10 Mb/s Single Twisted Pair Ethernet

10BASE-T1L Draft 0.3 Technical Comments

Steffen Graber
Pepperl+Fuchs

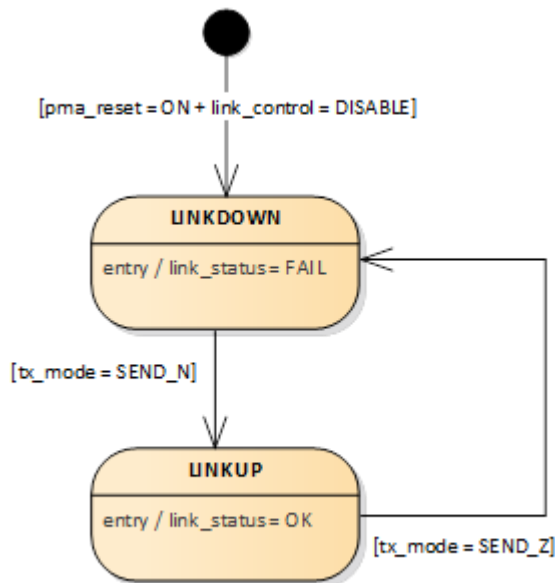
The reason for only having this very simple link monitor state machine is, that most of the link monitor functionality is already handled by the PHY control state machine, as it is also needed there. If the local or remote receiver status are bad or there is no scrambler lock, then the PHY control state machine switches automatically back to `SEND_Z` mode (going over `SEND_I` mode before) to get both PHYs in sync again. The link status therefore can be derived from the `tx_mode` value.

The `link_status` is ok, if the PHY is in `SEND_N` mode or (temporarily) in `SEND_I` while it is trying to recover the link. If the PHY starts a retraining, the PHY control state machine automatically goes to `SEND_Z` and the link status is then set to `FAIL`. As most of the functionality is therefore already in the PHY control state machine, the Link Monitor state machine got such simple.

As other PHYs also specify a link monitor state diagram and to keep the structure of this PHY aligned, it also uses a (very simple) link monitor state machine (alternatively we could split the SEND IDLE state in the PHY control state machine to include the logic into the PHY control state machine and omit the link monitor state machine).

The mode_changed flag is accidentally coming from implementation details. It should have been left out here as it is not necessary to implement it in the state machine (it is enough to just compare for the tx_mode variable).

Variables (to be added to the draft document):

tx_mode The tx_mode parameter set by the PMA PHY Control function and passed to the PCS via the PMA_TXMODE.indication primitive.

Values: SEND_Z, SEND_N, or SEND_I

link_status The link_status parameter set by PMA Link Monitor and passed to the PCS via the PMA_LINK.indication primitive.

Values: OK or FAIL
